City of Rochester

Re: Addenda to Tunnel Project Work Plan for Contaminated Soils

Re: Response to comments Court Street Parking Garage IRM

**RE: Court Street Parking Garage
Interim Remedial Measure (IRM) Work Plan (March 1994)**

LOCATION DRAWING SOIL CONTAMINATION FINDINGS TO DATE 1/5/94 1/31/94

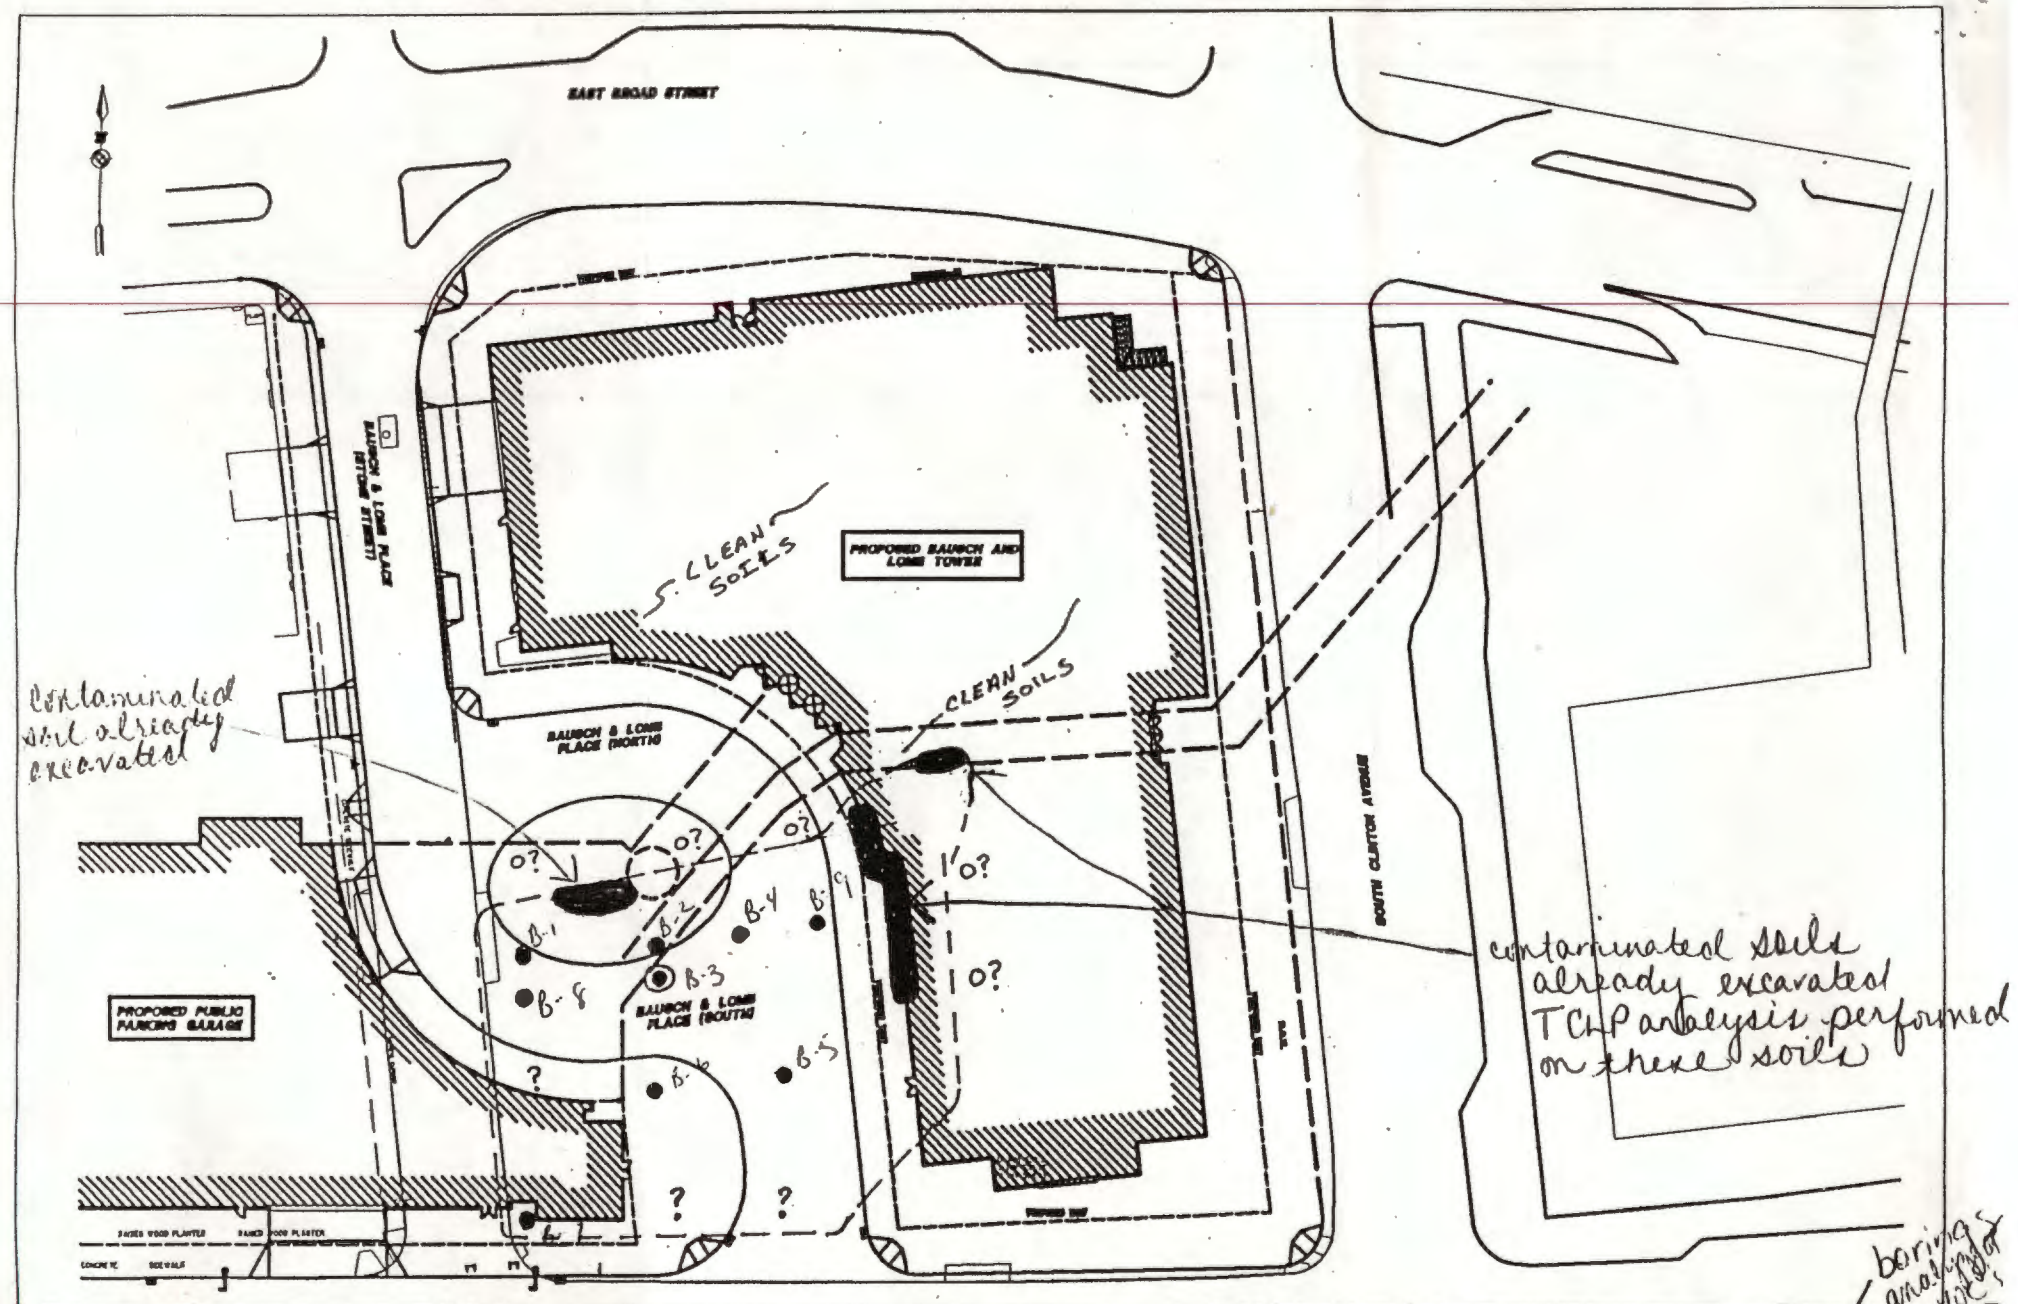
I have added some clarifying information on the site drawing enclosed. The large darkened areas on the drawing are Stoddard contaminated soils which have been excavated as part of construction activities on site to date. The remaining contaminated soil will be excavated upon demolition of an existing building (Speedy Cleaners).

The results of these analyses show the soil to be contaminated with petroleum compounds consistent with Stoddard Solvent. One area, however (B-3), was shown to contain tetrachloroethylene. This area will be excavated separately and managed as a hazardous waste.
